REFERENCE: Docket 50-186  
University of Missouri-Columbia Research Reactor  
Renewed Facility Operating License No. R-103

SUBJECT: Written communication as specified by 10 CFR 50.4(b)(1) regarding responses to the  
"University of Missouri at Columbia - Request for Additional Information RE: License  
Amendment Request to Implement Selective Gas Extraction Target Experimental  
Facility at the University of Missouri Research Reactor (CAC No. MF9524)," dated  
September 7, 2017

By letter dated September 7, 2017, the NRC requested additional information and clarification regarding the proposed LAR in the form of thirty-eight (38) questions (numbered 1 through 38).

Below are MURR’s responses to the September 7, 2017 request for additional information, including enclosures of supporting documentation.

Figure 3-1  
Target Cooling System Module Inlet Piping Assembly

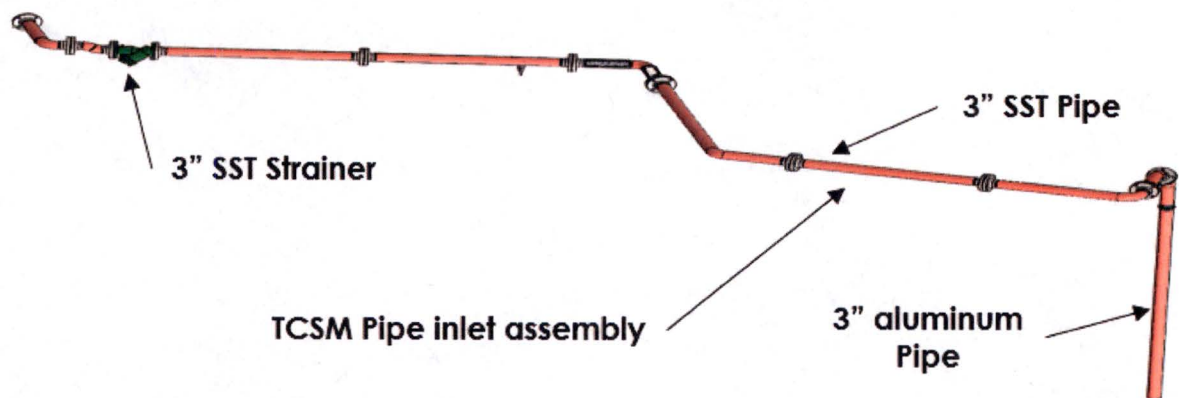
3.1. A detailed description and drawings of the pipe inlet and screen.

Figure 3-1 shows the 3D model of the inlet piping assembly that transports cooling water from the MURR reactor pool to the pump suction in the Target Cooling System Module (TCSM). The inlet piping assembly consists of 3-inch schedule 40 pipe made from both aluminum (inside the pool) and stainless steel (outside the pool) with a total length of 52 feet (15.8 m). This section of piping contains an inline strainer purchased from a qualified supplier that is installed upstream of the pump suction. The strainer has a straining element with a 3/16-inch mesh size that has a 5/32-inch flow opening to protect the pump (Appendix 3-1 shows the detailed layout of the proposed strainer and its internal components). Figure 3-2 shows the location of the inlet pipe relative to the TCSM assembly.

Figure 4.a  
Overall Target Experimental Facility Control System Block Diagram

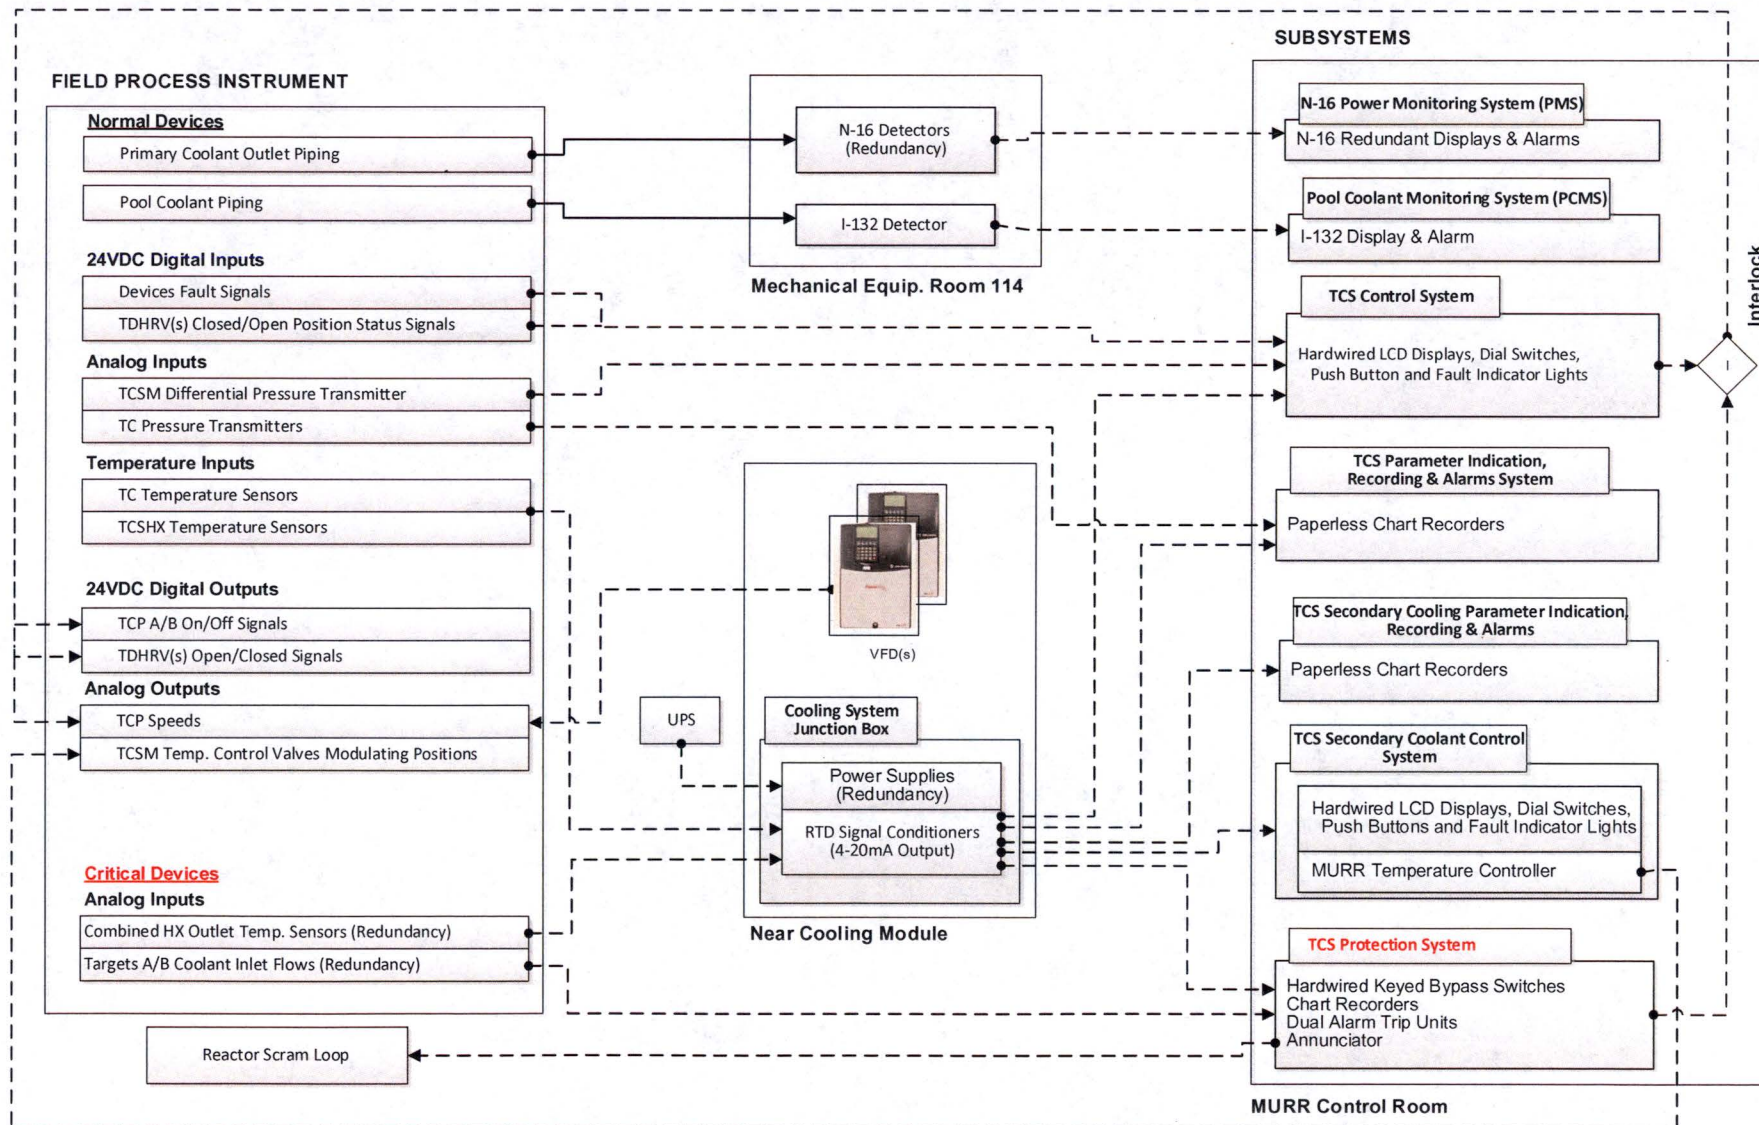
- 4.1. For each of the systems listed above, (a) through (g), provide an overall block logic, and process flow diagrams showing major components and subsystems, and connections for the I&C, or justify why no additional information is needed.

- 4.a Overall Target Experimental Facility Control System Block Diagram
- 4.b TCS Process Flow Diagram with Instrumentation & Control Connections
- 4.c TCS Process Flow Diagram
- 4.d TCS Secondary Coolant Process Flow Diagram with Instrumentation & Control Connections
- 4.e Pool Coolant Monitoring System Process Flow Diagram with Instrumentation & Control Connections
- 4.f MURR Control Room Instrument Cabinet
- 4-1.a TCS Control Subsystem Block Diagram including Scram Interface
- 4-1.b TCS Protection Subsystem Control Block Diagram
- 4-1.c TCS Parameter Indication, Recording and Alarm Subsystem Block Diagram
- 4-1.d TCS Secondary Coolant Control System Block Diagram
- 4-1.e TCS Secondary Coolant Parameter Indication, Recording, and Alarm System Block Diagram
- 4-1.f N-16 Reactor Power Monitoring System Block Diagram
- 4-1.g Pool Coolant Monitoring System Block Diagram

Figure 4.f  
MURR Control Room Instrument Cabinet

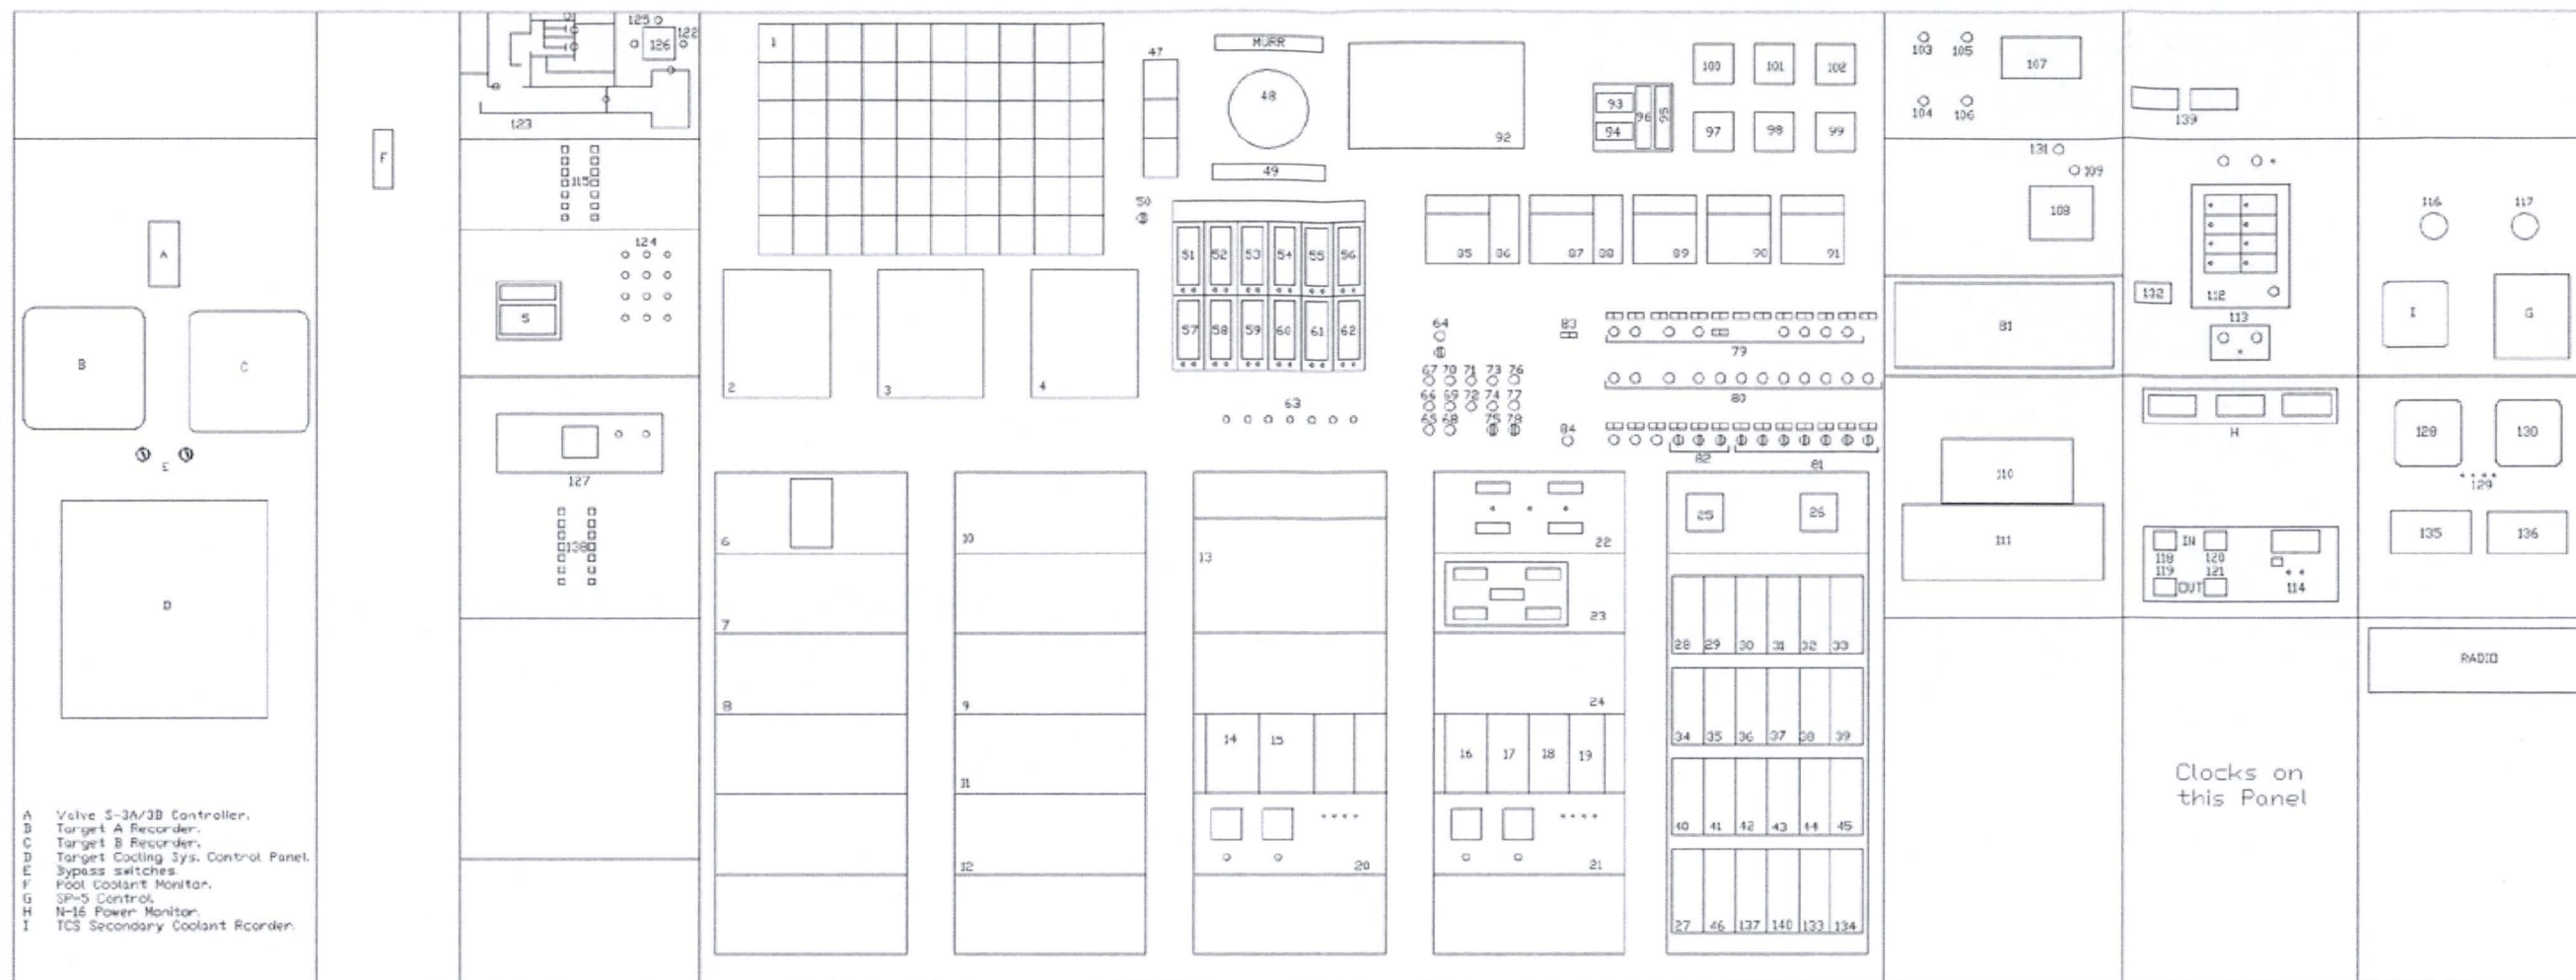
*4.3.4. Provide diagrams that illustrate the various control panel layouts for controls and indicators, including labeling and color schemes (similar to Figure 31 for the TCS Control Panel). Additionally, provide a general depiction of where all of the system control and indicators are located in relation to the operator or justify why no additional information is needed.*

The TCP control system with its associated alarms and warning lights will be placed within easy view of the Console operator. It will be to the operator's left as the operator is sitting at the reactor control console. When the operator is standing near the TCS control panel, the switches of the panel are in easy reach of the operator. See the draft copy of the MURR Control Room Instrument Cabinet shown as Figure 4.f. During normal operation, the TCP control system will be started and flow rates adjusted prior to reactor startup so that during reactor startup and operation, the operator will have no need to adjust the TCP controls. The indication of all green lights and a lack of alarms will inform the operator that the TCP Control System is operating normally. The TCP control system is labeled 'D' on Figure 4.f.

The location of the indicators, alarms, and controls on the TCS control panel are described in the response to RAI No. 4.3.1 and are displayed in the TCS control panel layout in Figure 4-3.a. The TCS control system has a TCS control panel located in the MURR control room as shown on Figure 4.f, "MURR Control Room Instrument Cabinet." The entire MURR Control Room Instrument Cabinet, including all its components, is in easy view of the Console operator. The TCS control panel is labeled "D" on Figure 4.f.

These chart recorders are labeled 'B' and 'C' on Figure 4.f.

The keyed bypass switches will be left of the operator sitting at the reactor control console. The switches will be on the MURR Instrument Cabinet. The switches are labeled 'E' on Figure 4.f. The switches are purposely placed near the TCS control panel and at easy eye level to see when they are inserted. The presence of the keys with bright yellow tags will infer a bypass is being used because the keys will be locked in a cabinet when no bypass function is required.

Figure 4-2.a  
Independent Hardwired Isolated Interface with MURR Scram Loop Block Diagram

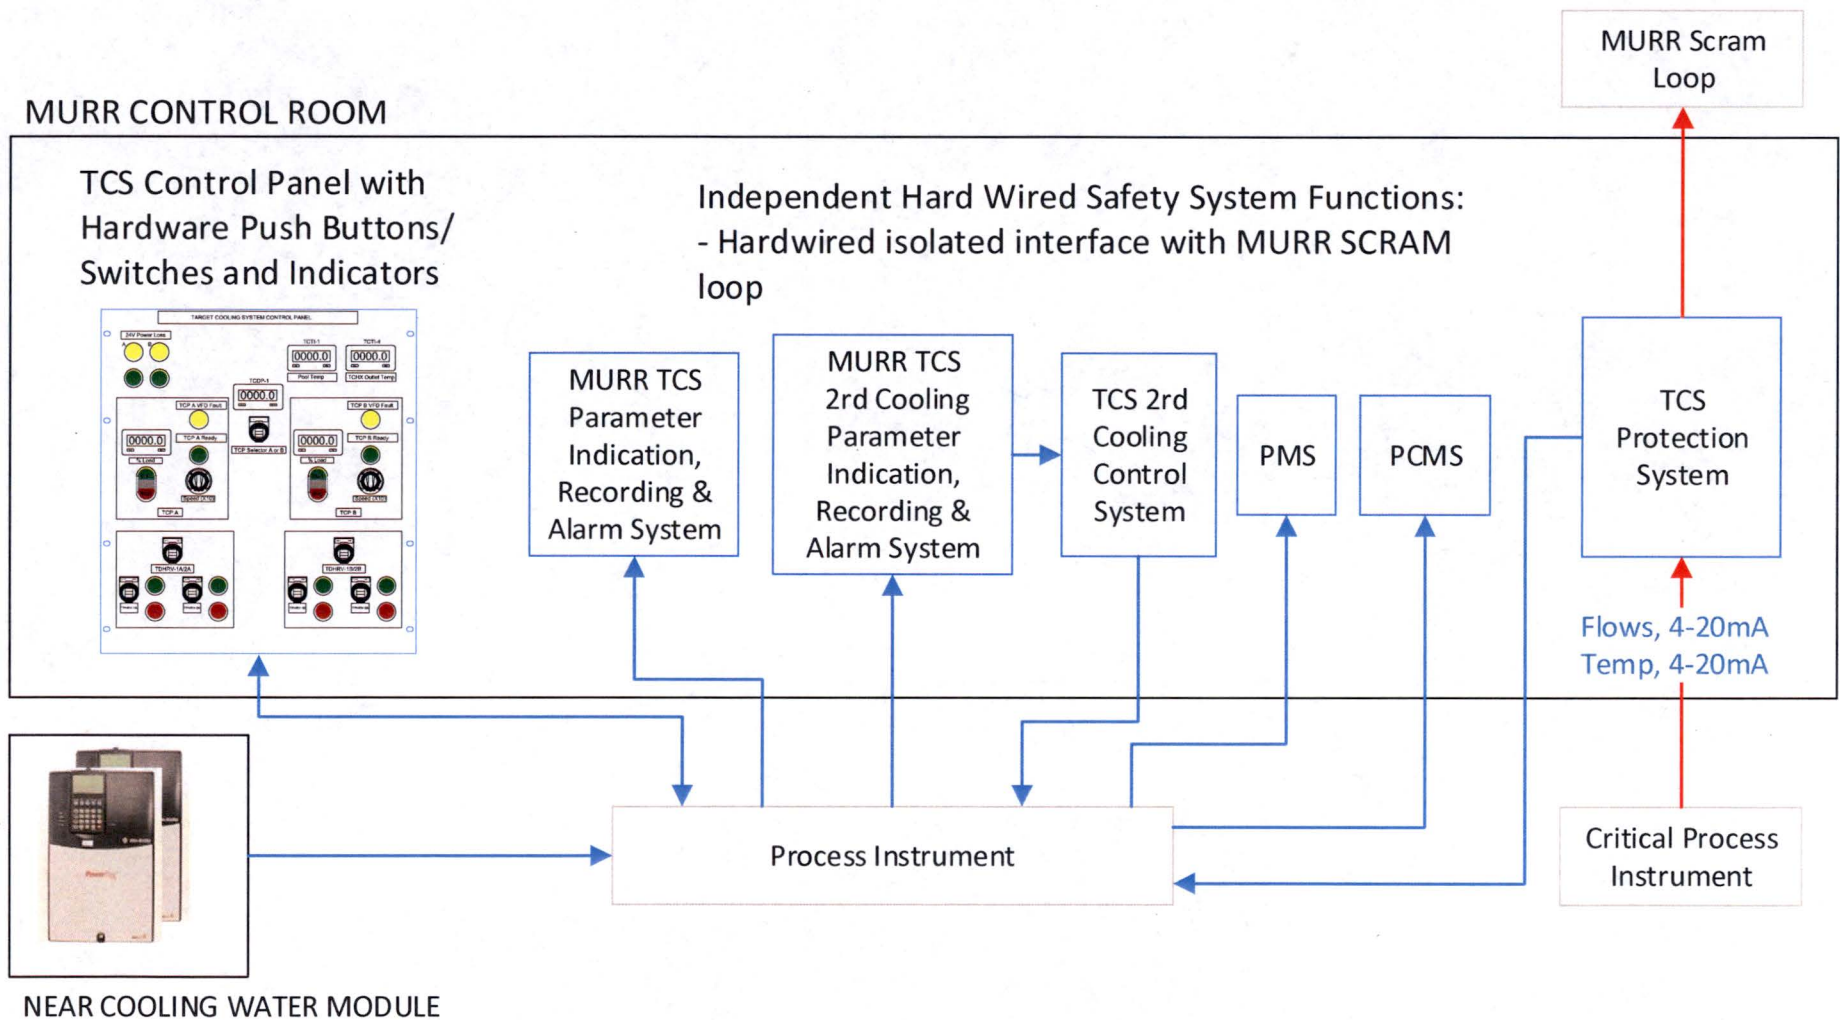
4.2. For each of the systems listed above, (a) through (g), provide more detail for the implementation of "Hardwired isolated interface with MURR SCRAM loop," (LAR, Attachment 1, Figure 30, page 54, "Target Cooling System Control System Architecture") used to describe the independent hard-wired safety function with regard to specific means of providing isolation or justify why no additional information is needed [draft ISG 7.1, 7.3, 7.4, 7.6, and 7.7].

Figure 4-2.a depicts all seven (7) sub-systems and shows that the critical process instruments are connected to the TCS protection system and MURR scram loop, which is independent from the process instruments for the other six (6) sub-systems, including the TCS control panel display as described above.

Figure 4-3.a  
Target Cooling System Control Panel Layout

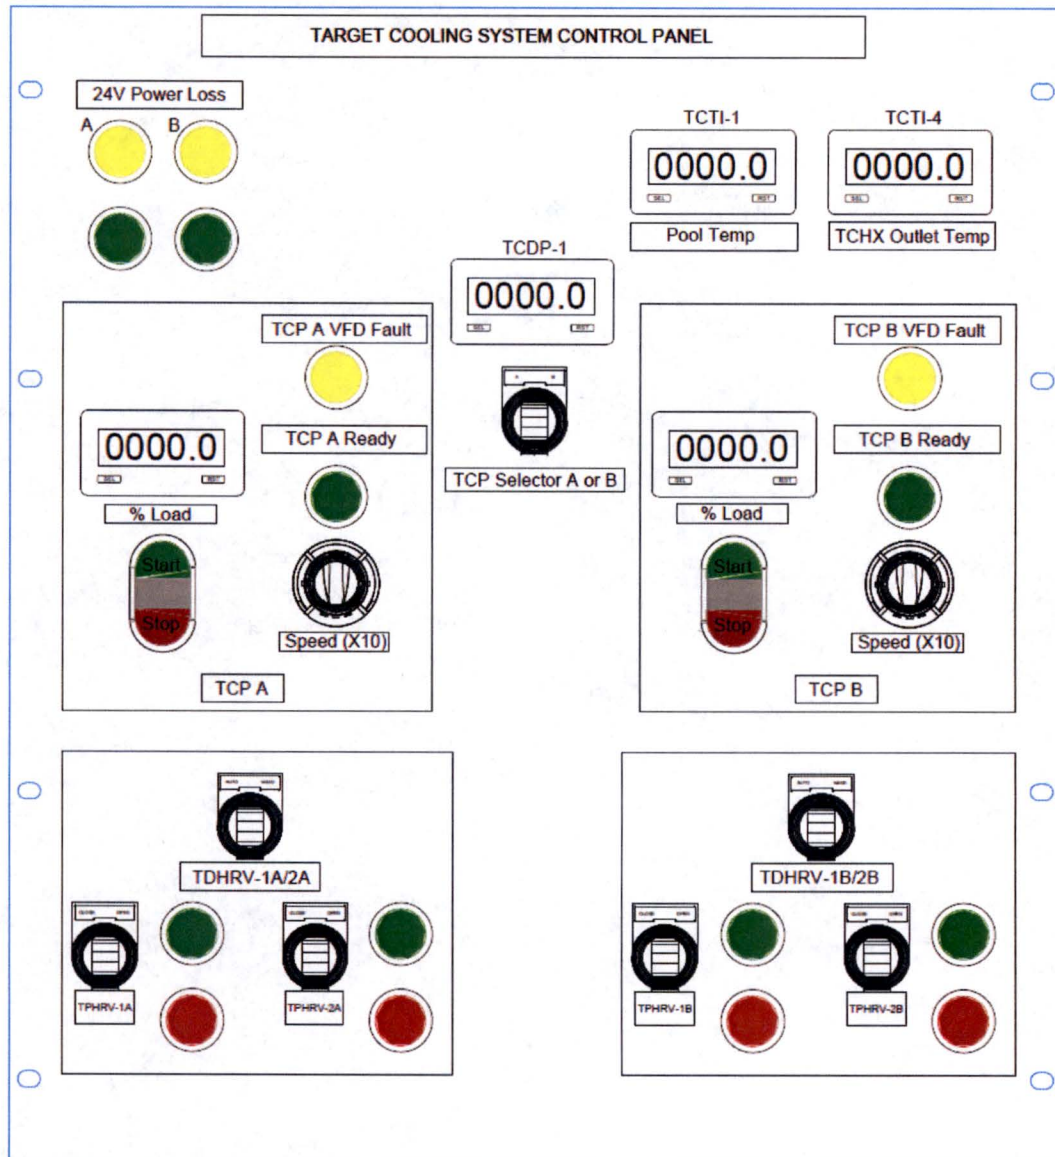
4.3.1. *Explain how control, safety, and associated TEF position indication systems and alarm and warning lights are displayed and readily accessible and understandable to the reactor operator or justify why no additional information is needed.*

The TCS control panel is shown in Figure 4-3.a. The indication lights on the TCS control panel are displayed based off the signals to the TCS control system.

The TCS control panel also includes indications of TCS pump load, differential pressure of the coolant (TCDP-1) across the Target Cooling System Module (TCSM), pool temperature (TCTI-1) and TCS heat exchanger (TCHX) coolant outlet temperature (TCTI-4). The pump load (%) indications show the ratio of TCS pump motor operating current (A) to the TCS pump motor maximum current (A) at 100% speed. The differential pressure (psid) (TCDP-1) indication

Figure 4.6  
Variable Frequency Drive Enclosure

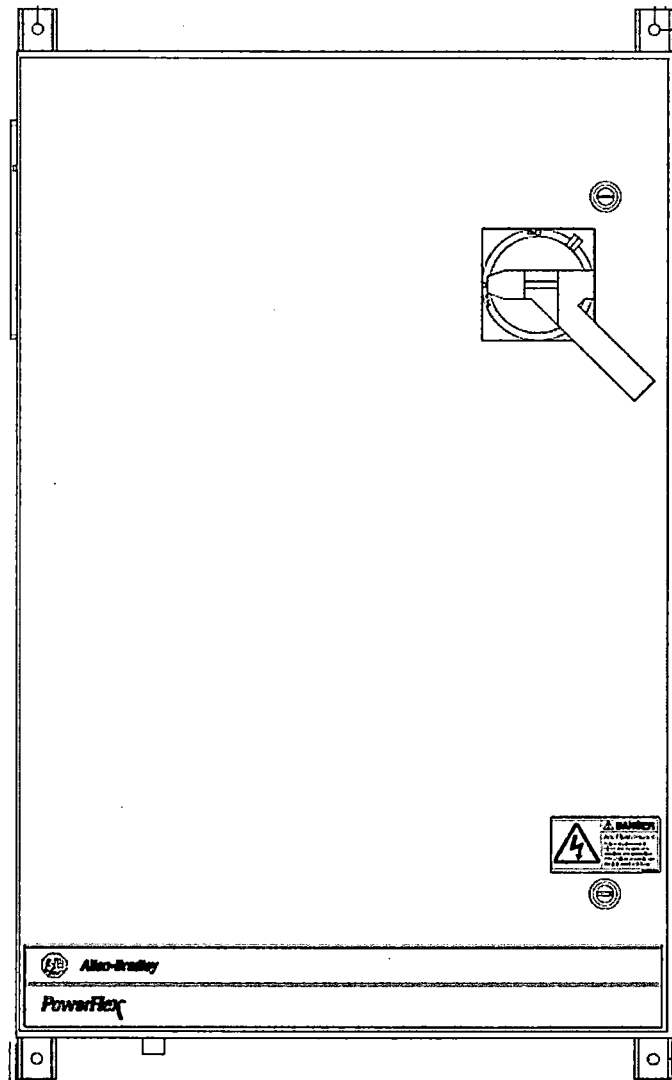
- 4.6. *The NRC staff review did not find a discussion of access control features (e.g., variable frequency drives with accessible control pads for local maintenance control shown in LAR, Attachment 1, page 54, Figure 30), to includes both preventing unauthorized access and allowing authorized access for both analog and digital systems (as applicable). Provide information on access controls such as alarms and locks on panel doors, or administrative control of access to rooms, and the protection of any networked systems (if applicable) or justify why no additional information is needed [draft ISG 7.2.5].*

Additionally, each VFD is located in an enclosure with a locked door handle, as shown in Figure 4.6. The VFD enclosures are located near the TCS pumps. The door is interlocked with a handle mechanism to prevent the door from being opened without first turning off power via the fused disconnect. There are two (2) ways to operate this handle. The first method requires the operator or maintenance personnel to turn off the high power feed to the VFD enclosure from distribution panel HVP-4 (Section 3.4.9 of LAR Part 1 Attachment 1) prior to opening the door. A second way allows the maintenance personnel to troubleshoot the VFD while energized. The handle does have an override mechanism that allows maintenance personnel to open the enclosure door without disconnecting the power for troubleshooting purposes, if needed. The handle also has padlock provisions for lock out/tag out.
